The enclosed Traffic Impact Study (TIS) review letter for the **Terraces at Pike Creek** (Tax Parcels: (Tax Parcels: 08-036.40-058, 08-042.40-134, and 08-036.10-109) residential development has been completed under the responsible charge of a registered professional engineer whose firm is authorized to work in the State of Delaware. They have found the TIS to conform to DelDOT's Development Coordination Manual and other accepted practices and procedures for such studies. DelDOT accepts this letter and concurs with the recommendations. If you have any questions concerning this letter or the enclosed review letter, please contact me at Annamaria.Furmato@delaware.gov.

RE: Agreement No. 1946F
Traffic Impact Study Services
Task No. 4A Subtask 21A – Terraces at Pike Creek

McCormick Taylor has completed its review of the Traffic Impact Study (TIS) for the Terraces at Pike Creek residential development prepared by McMahan dated July 17, 2023. McMahan prepared the report in a manner generally consistent with DelDOT's Development Coordination Manual.

- Scope of Improvements Figure**
Terraces at Pike Creek TIS
- DelDOT Access A – add WB left-turn lane
 - DelDOT Access B – no improvements
 - New Castle County access
 - Study Intersection – No Improvements

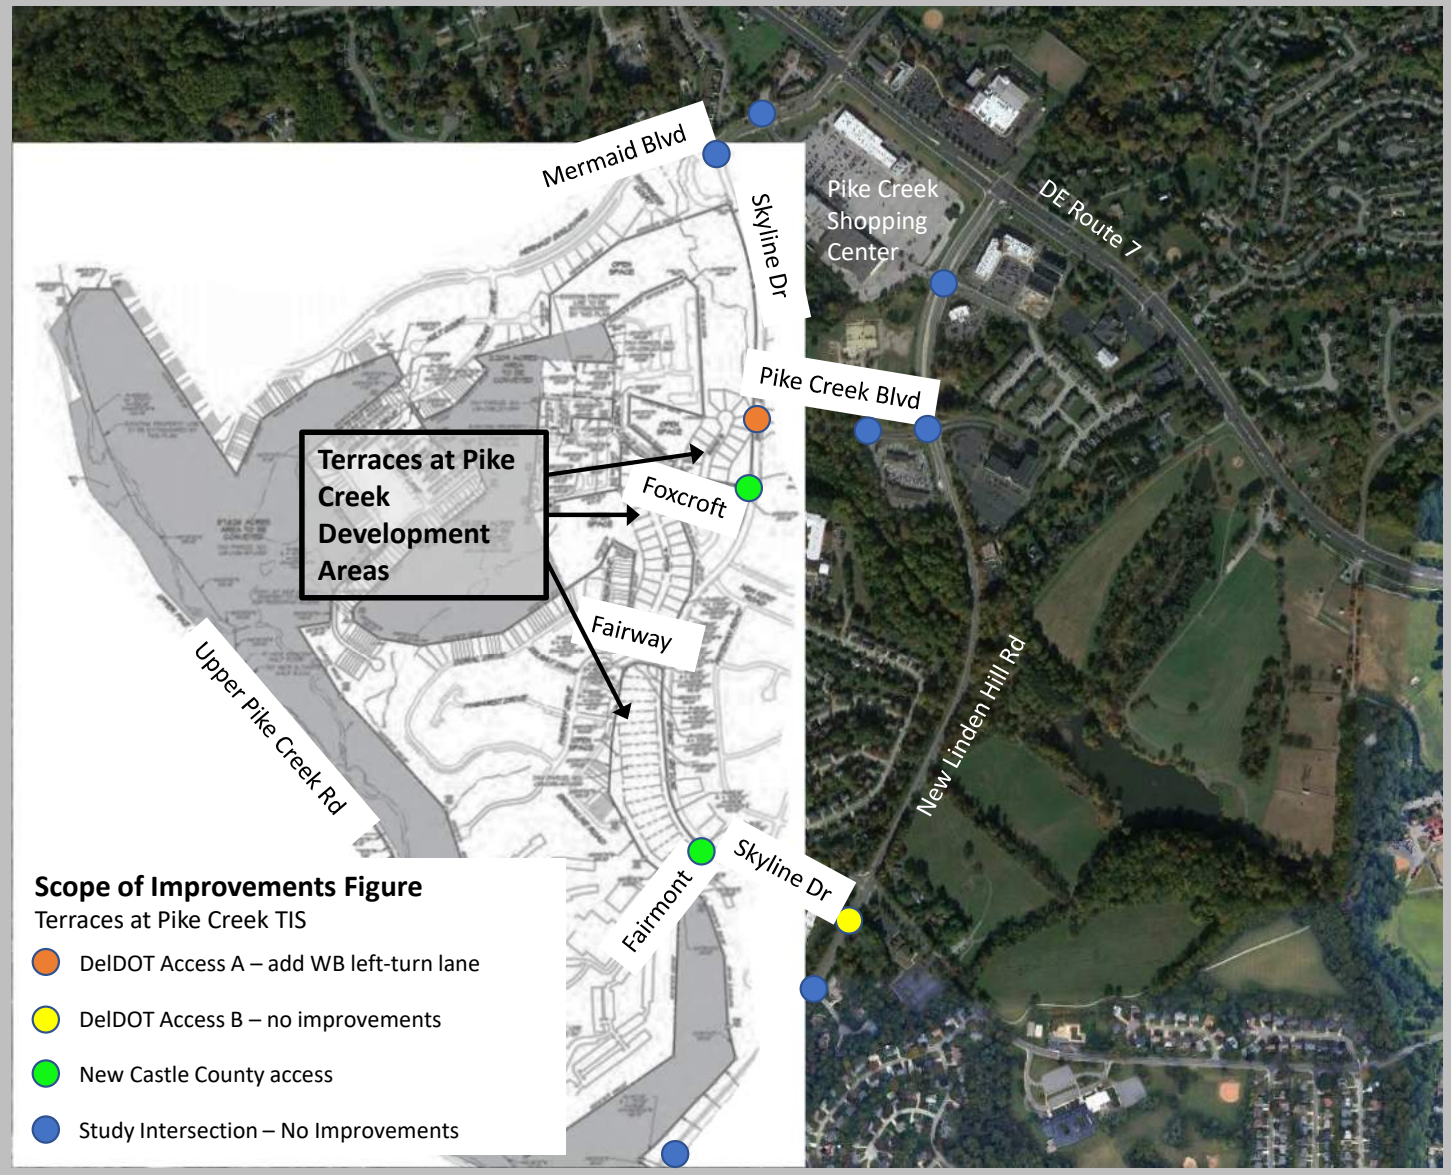
This unsignalized intersection would operate with level of service deficiencies on the stop-controlled westbound approach of Pike Creek Boulevard during the future AM peak hour without development (LOS E) and with development (LOS F). The 95th percentile queue length on the westbound approach during the future with development AM peak hour would be approximately 200 feet long. The westbound approach currently has one shared left/right-turn lane. Modifying the westbound approach to separate the turn lanes would mitigate the LOS deficiency and reduce the queue length to approximately 100 feet long. We recommend that the developer add a separate left-turn lane on the westbound Pike Creek Boulevard approach.

- The developer should modify the intersection of Skyline Drive (DeIDOT Site Access A) and Pike Creek Boulevard. The proposed configuration is shown in the table below.

On the westbound Pike Creek Boulevard approach, the creation of separate left and right turn lanes should be accomplished by modifying the existing grass median to create a dedicated left-turn lane. Initial recommended minimum turn-lane lengths (excluding tapers) of the separate turn lanes are listed below. The developer should coordinate with DeIDOT’s Development Coordination Section to determine final turn-lane lengths and other design details during the site plan review.
